TECHNICAL SERVICE BULLETIN

Bulletin Number: 2010-05 T

SUBJECT: Maintenance Required Notification

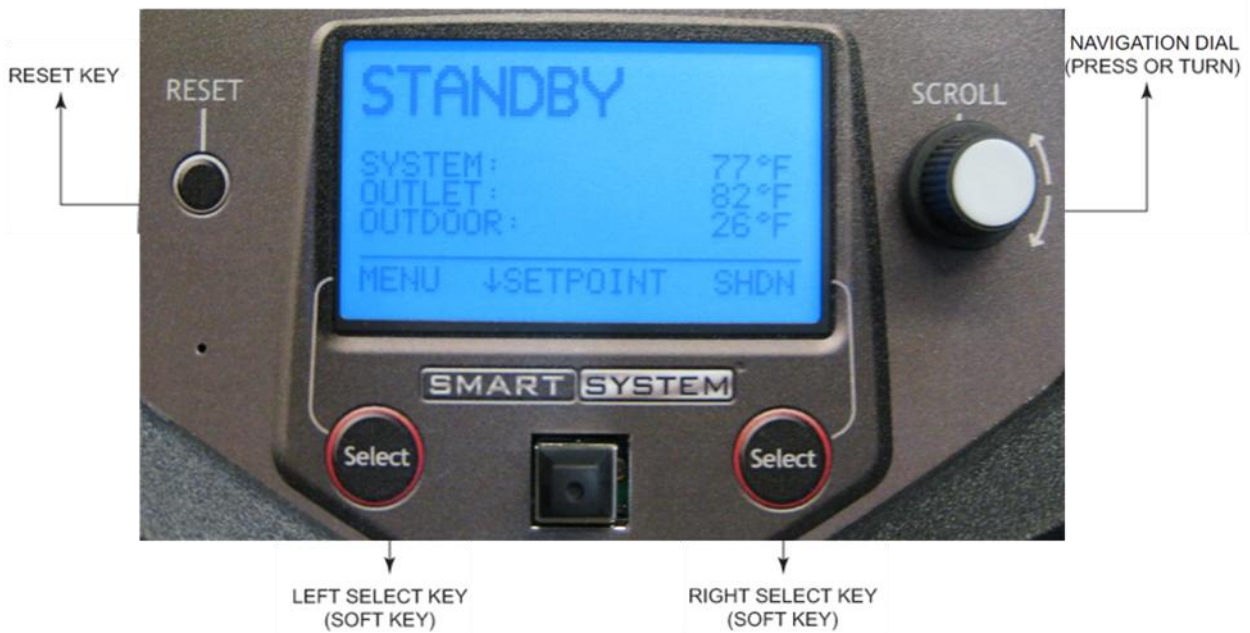
Lochinvar has discovered that the Maintenance Required notification screen will incorrectly show up on a monthly basis on the following boiler models manufactured prior to August 1, 2010 (Prior to Serial number beginning with H10):

The time based notification that is occurring monthly can be disabled by the instructions on the following page:

If you or your customer would like to retain the option of receiving the Service Notification based on 12 month of operation of the boiler, a new upgraded User Interface Control will need to be installed. Lochinvar will gladly provide a replacement User Interface Control for you through your Lochinvar representative. Please contact your local Lochinvar representative and request a replacement User Interface Control (RLY20058).
